Addendum Number: One Architect's Project #: 2023

CN Catoosa Child

Development Center

From: BLUE RIVER ARCHITECTS,

SHEET NAME:
IRRIGATION KEY
PLAN

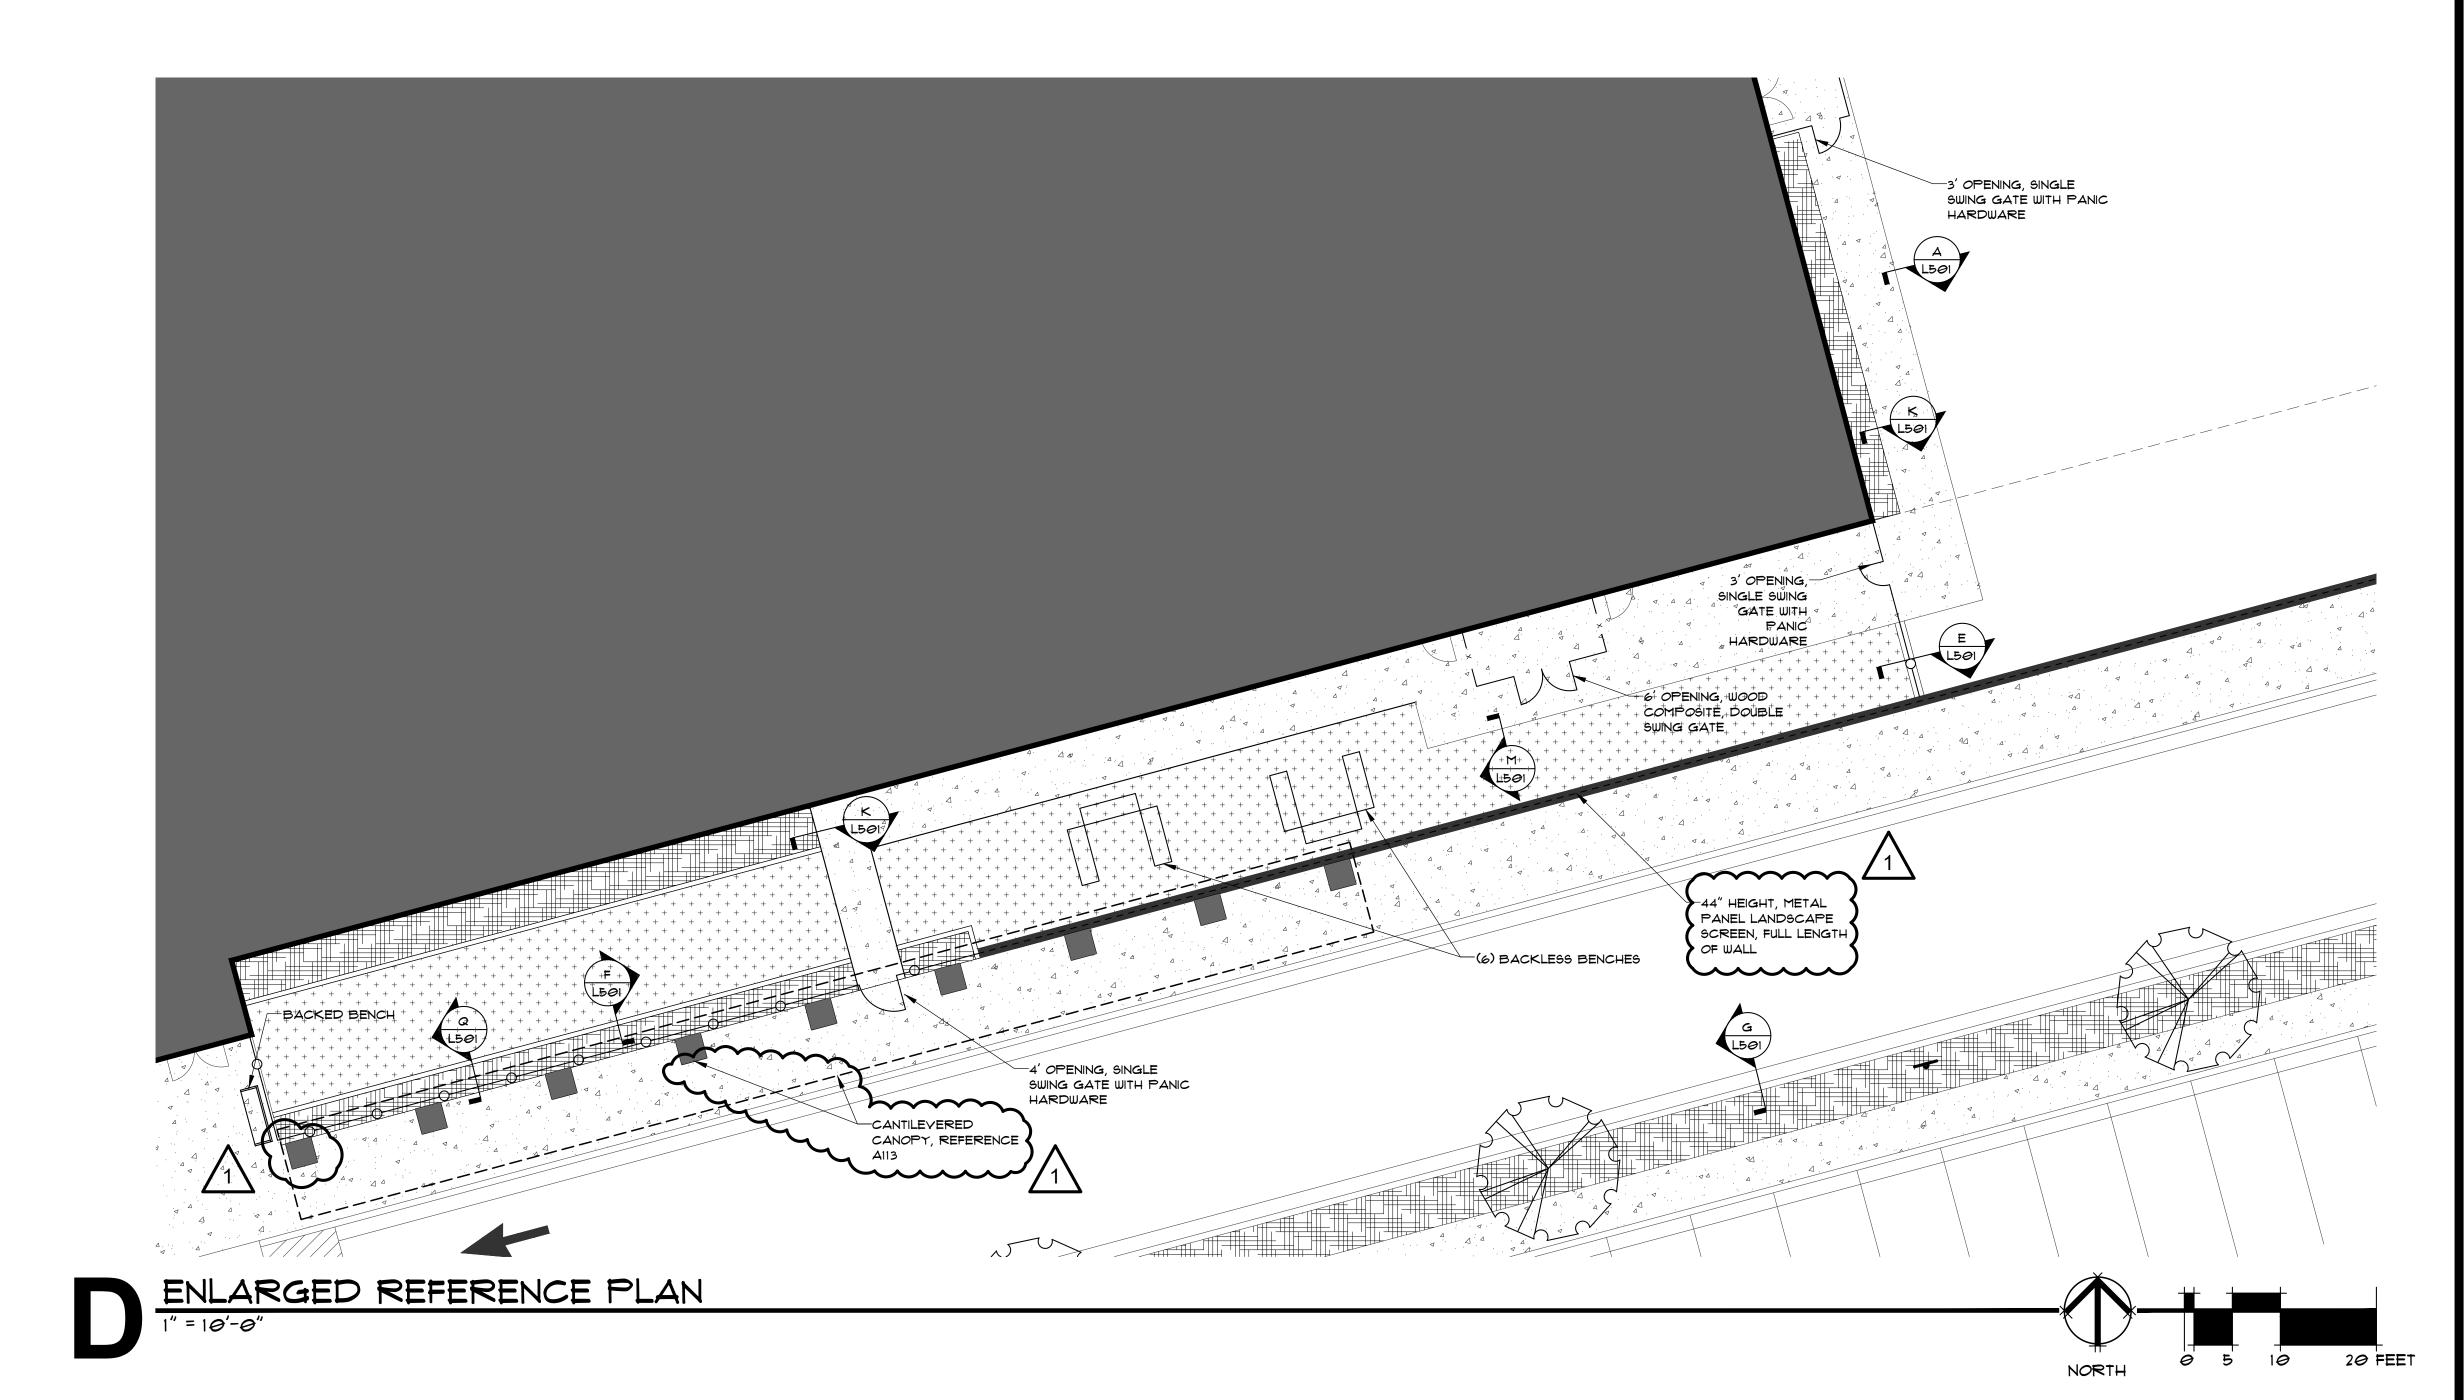
- 16.2 Adjust legend titles for synthetic turf.
- 17. Sheet L102 Irrigation Key Plan
 - 17.1 Irrigation callout for green roof gazebo added.
- 18. Sheet L201 Enlarged Reference Plans

SHEET NAME:
ENLARGED
REFERENCE PLANS

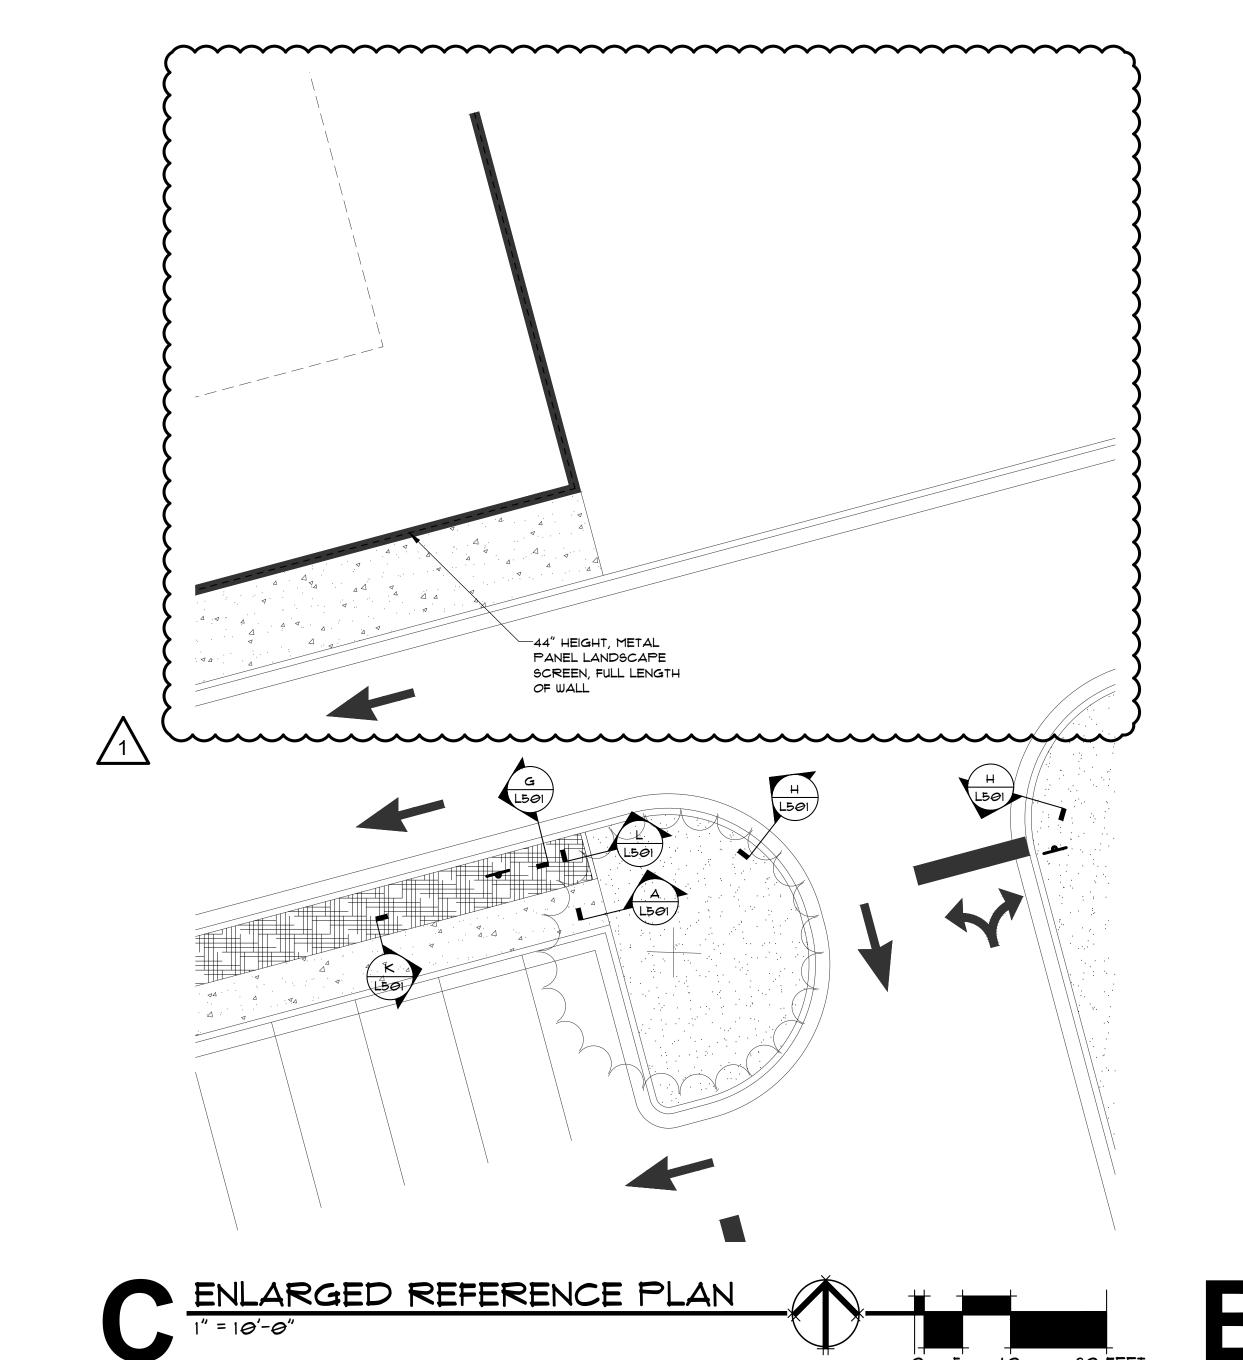
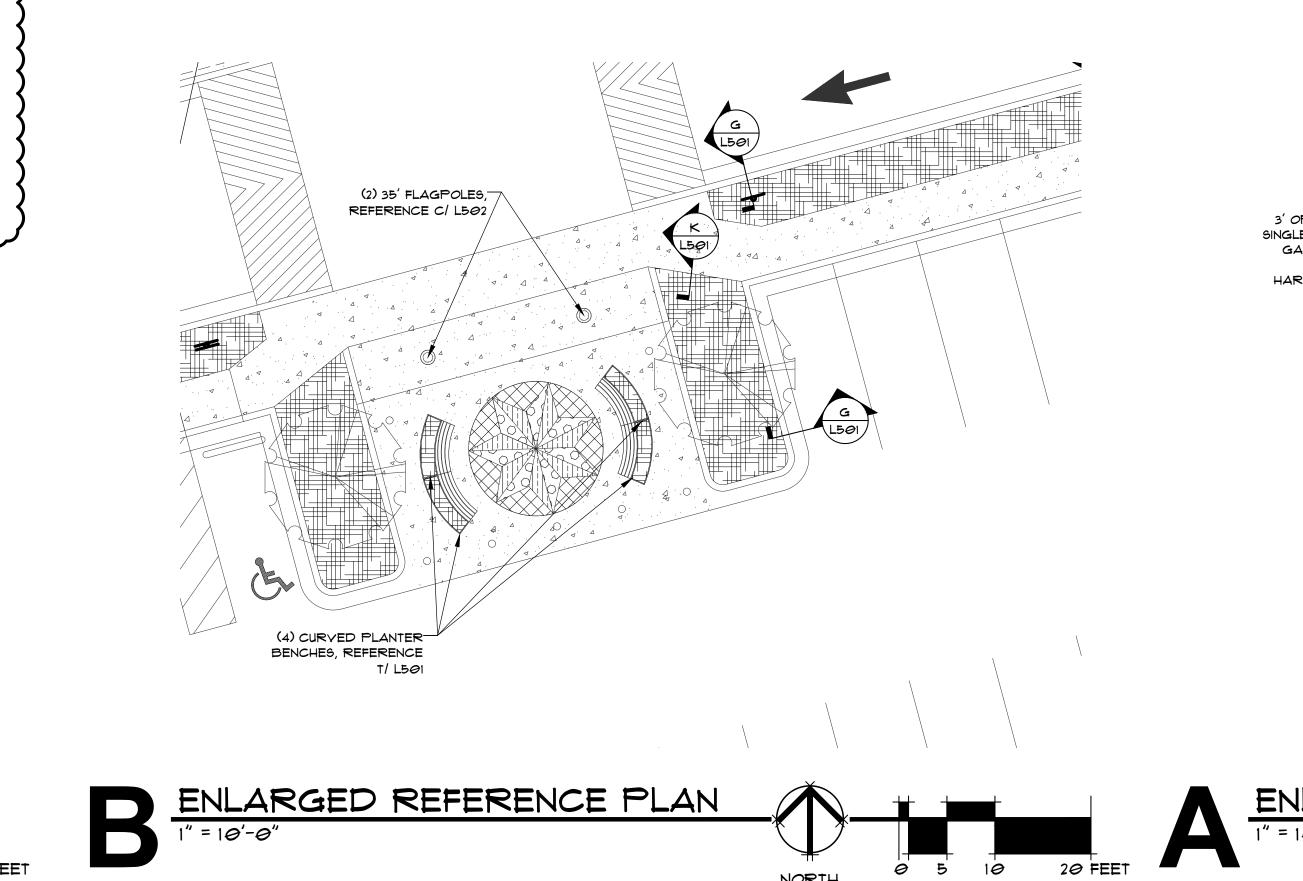
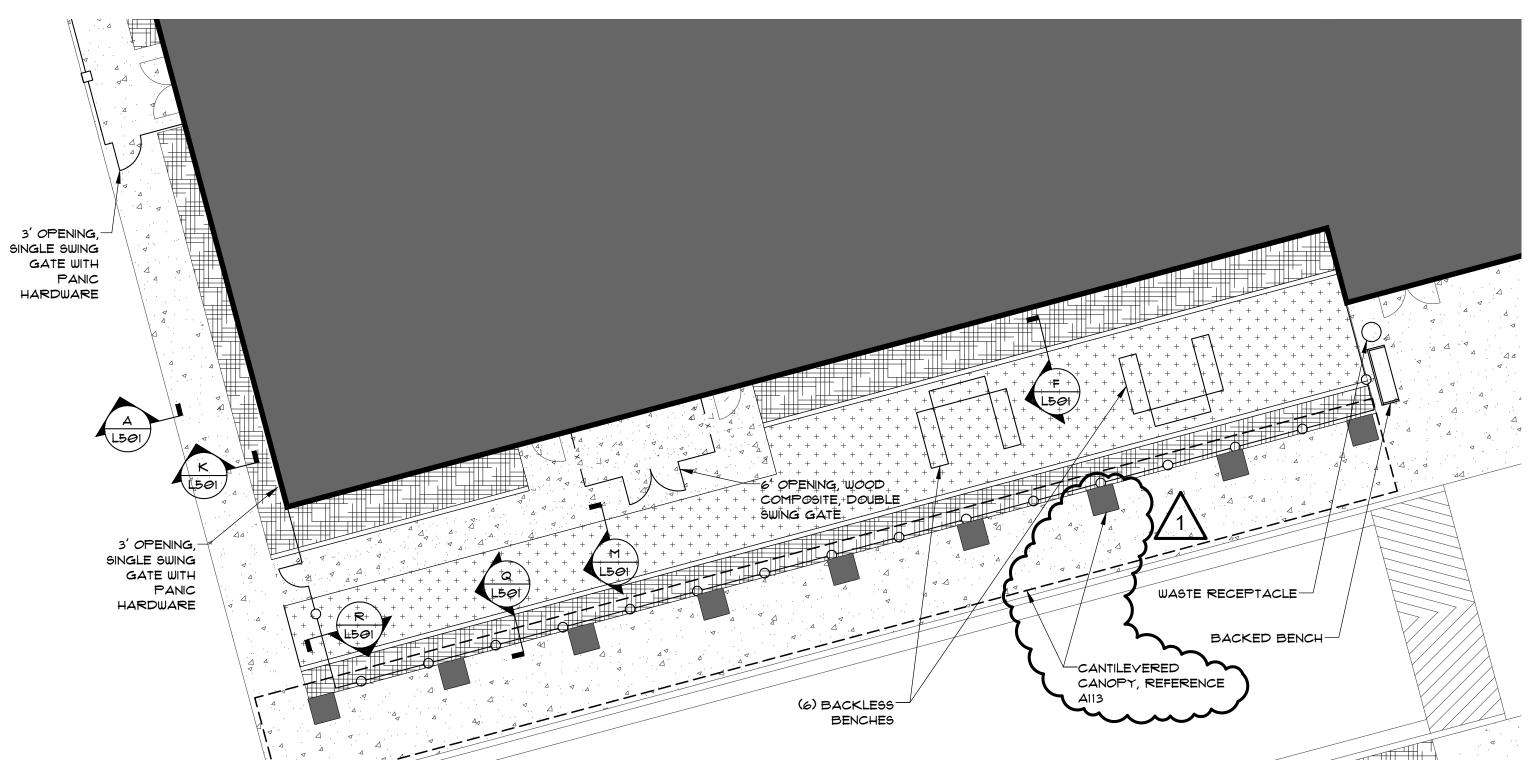
- 18.1 Green roof gazebo added to plan.
 - 18.2 Adjust legend titles for synthetic turf.
- 19. Sheet L202 Enlarged Reference Plans
 - 19.1 Cantilevered canopy callouts updated.

- 19.2 Metal panel landscape screen callout updated.
 - 19.3 Expanded Enlargement C.
- 20. Sheet L401 Planting Plan Overall
 - 20.1 Green roof gazebo added to plan.

SHEET NAME:
PLANTING PLANS

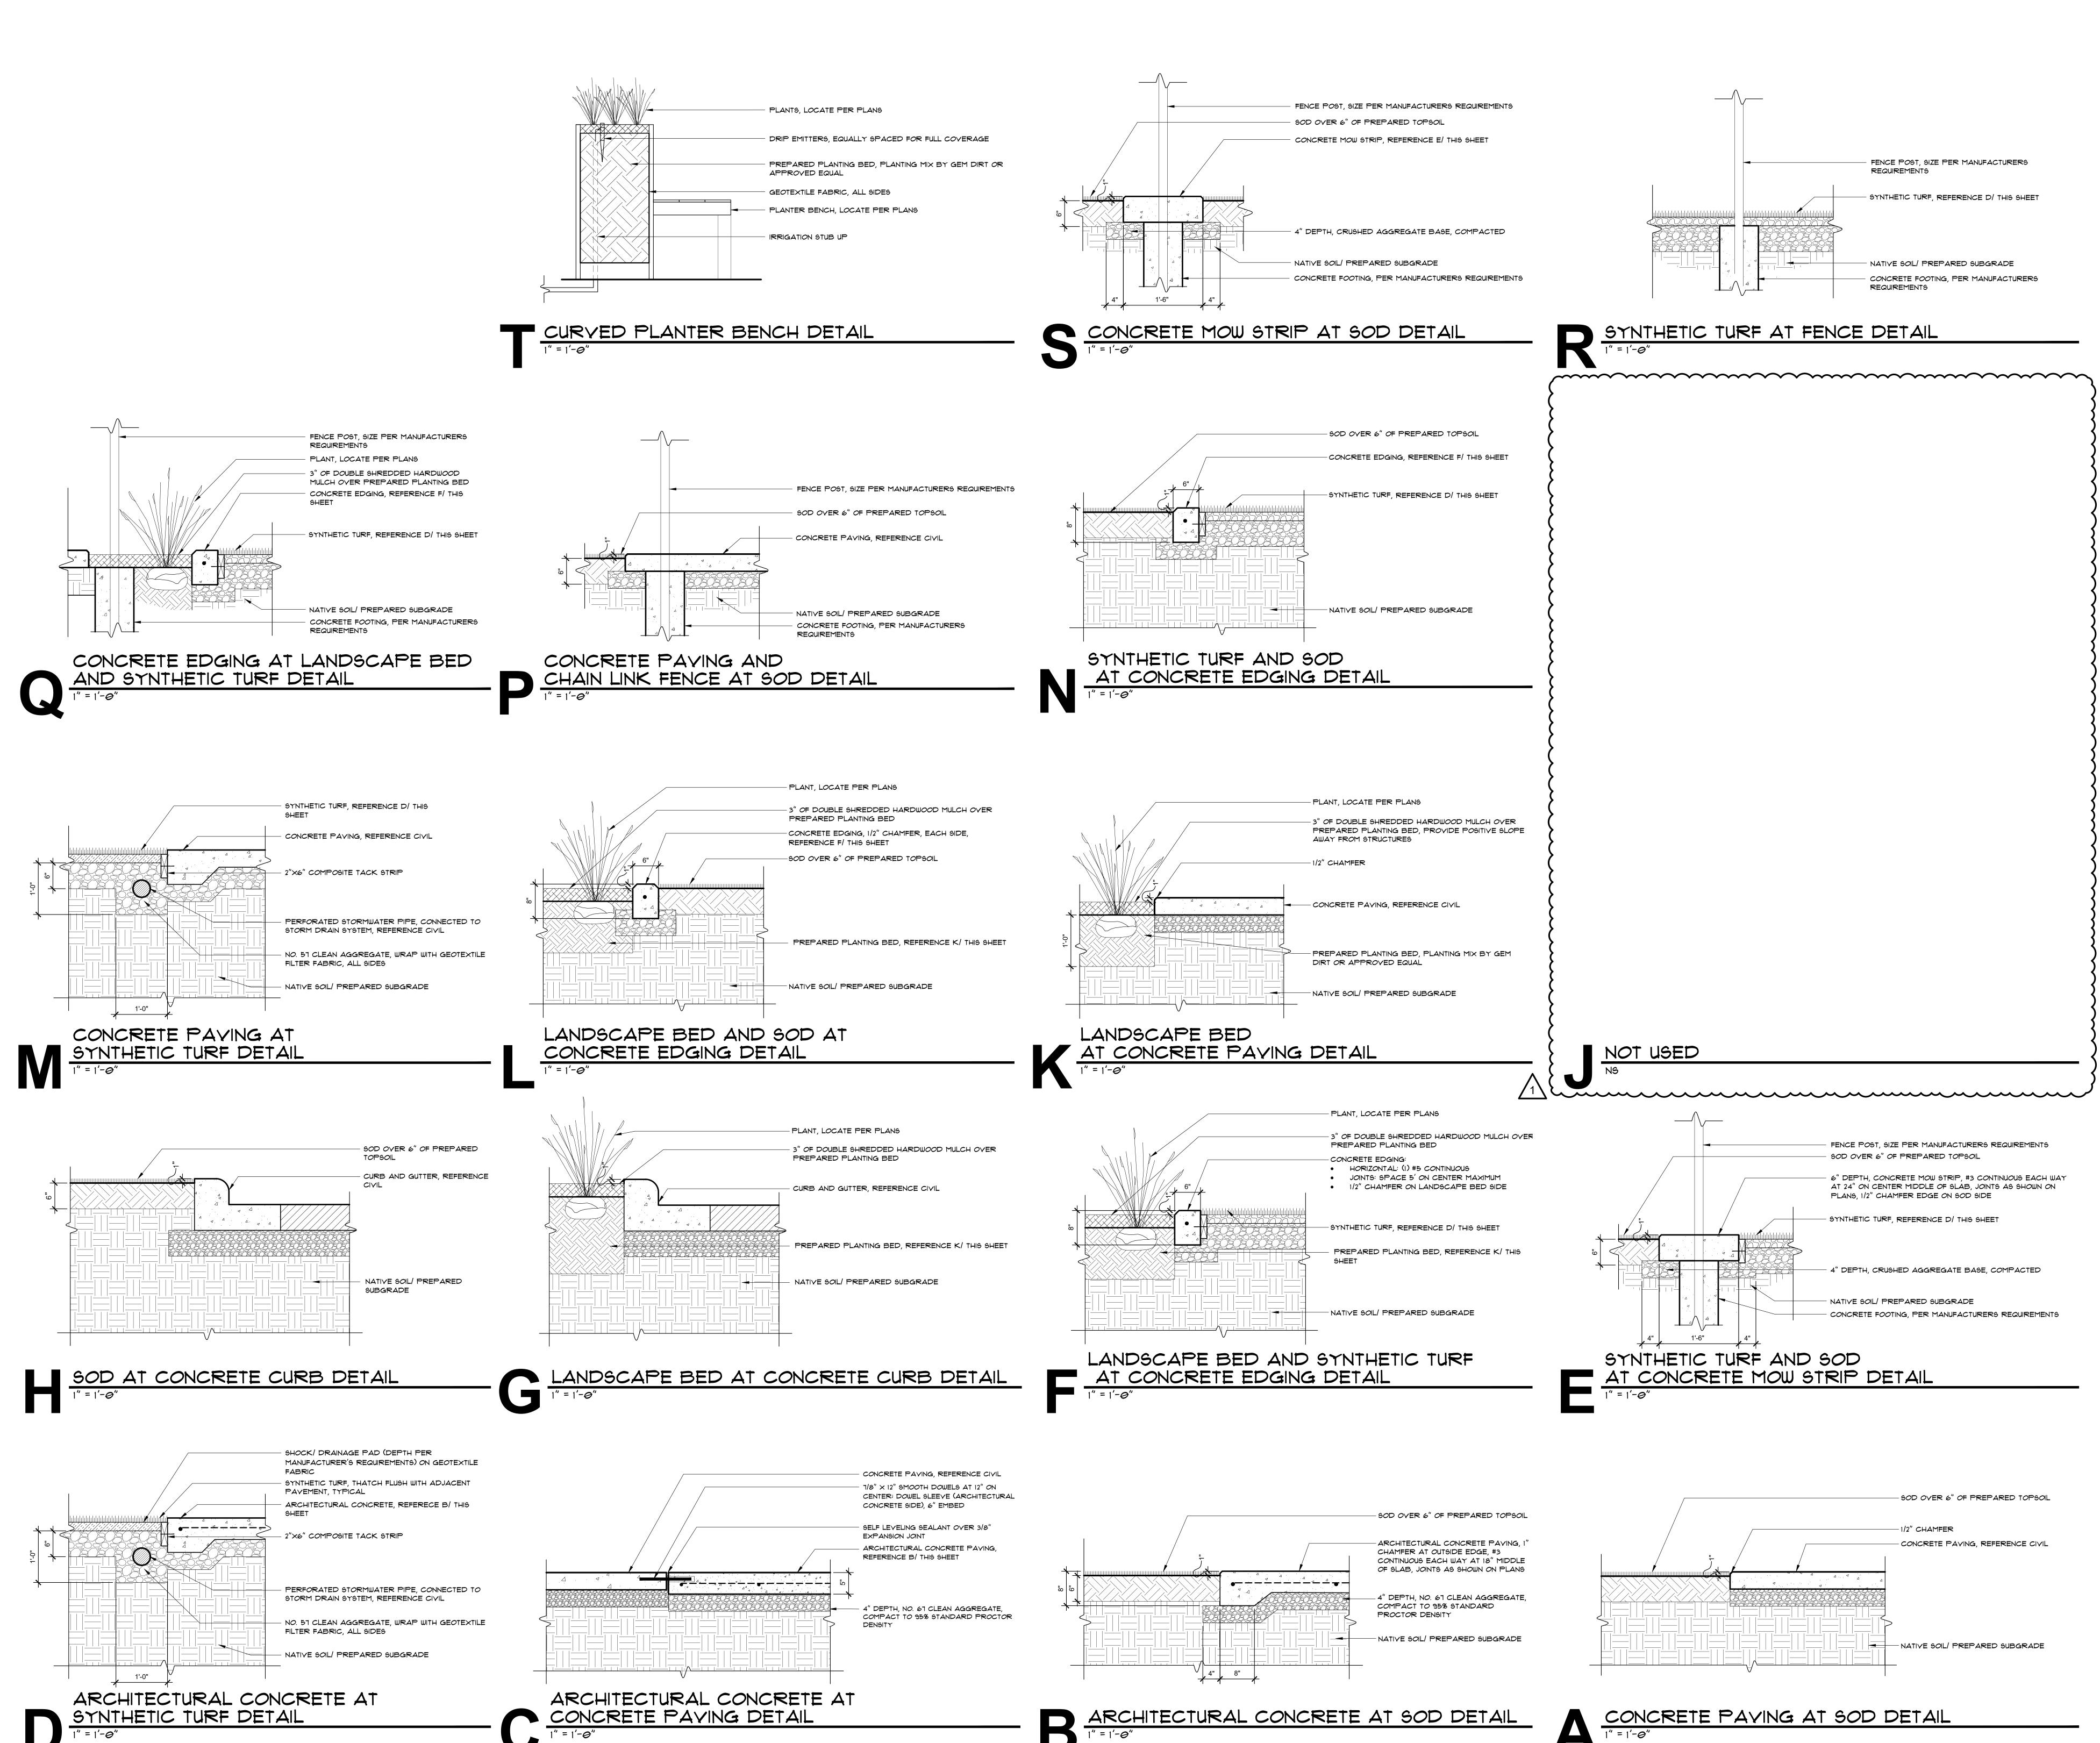
- 21. Sheet L402 Planting Plans
 - 21.1 Green roof gazebo Plan B added.
 - 21.2 Added legend for green roof gazebo.
- 22. Sheet L501 Details
 - 22.1 Removed detail J.
